RIIO-T1 STAGE 4

NGET FINAL ASSESSMENT

A report to Ofgem

June 2012

Figure 2 – RIIO-T1 Scenario 1

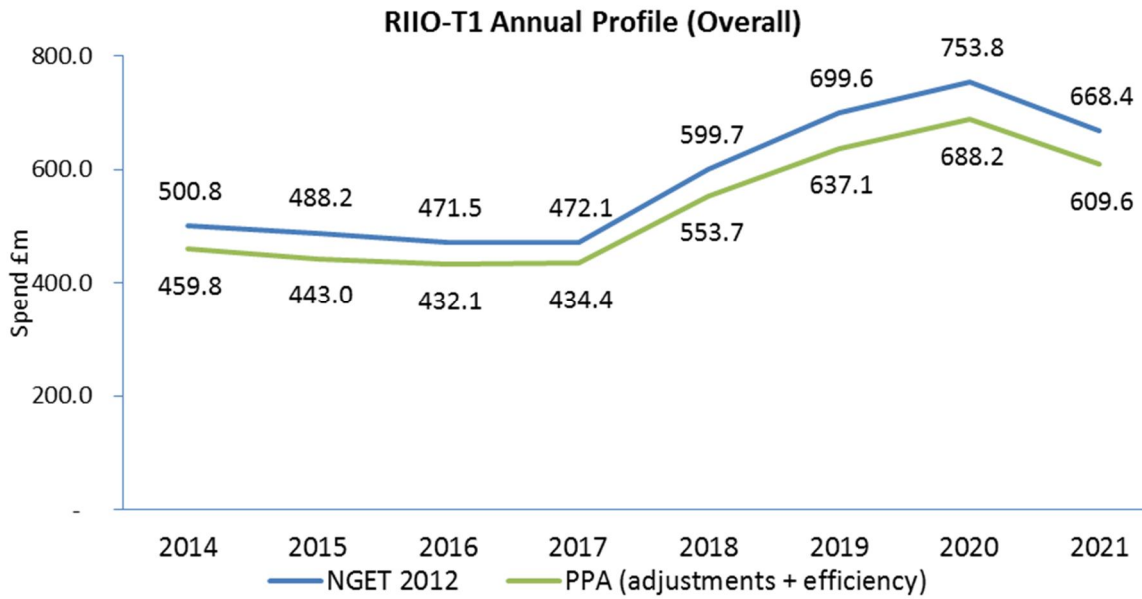
- Scenario 1 in Figure 2 represents a cut in allowances of 8.2% in 2014, rising to 8.8% at the end of the RIIO-T1 period; and
- Scenario 2 in Figure 3 represents an initial cut of 11.8% rising to 12.5%.
